**Re: Albuquerque Retirement Residence, 8301 Palomas NE,
(D-19/D025)**

**Re: Albuquerque Retirement Residence Grading and Drainage Plan
Engineer's Stamp dated 4-10-07 (D19/D25)**

Re: Albuquerque Retirement Residence, Lots 19-22 Block 21 Tract A
Grading and Drainage Plan
Engineer's Stamp dated 12-13-06 (D19/D25)

SUPPLEMENTAL INFORMATION

DRAINAGE BASIN

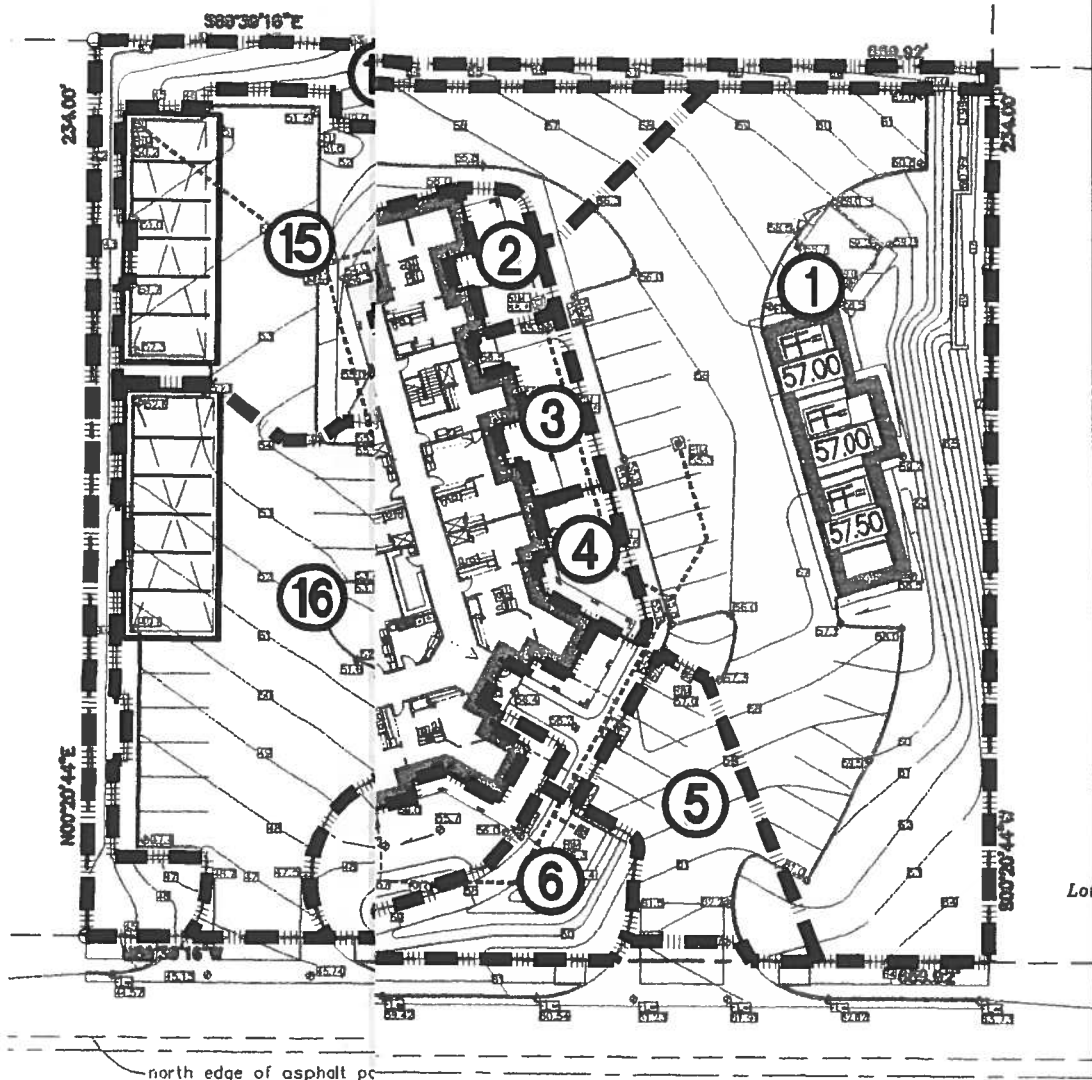
Weak - Should have cut up with which pipe it goes
 12' x 4.3' = 14 cfs to sink SD
 12' x 4.3' = 14 cfs to sink SD
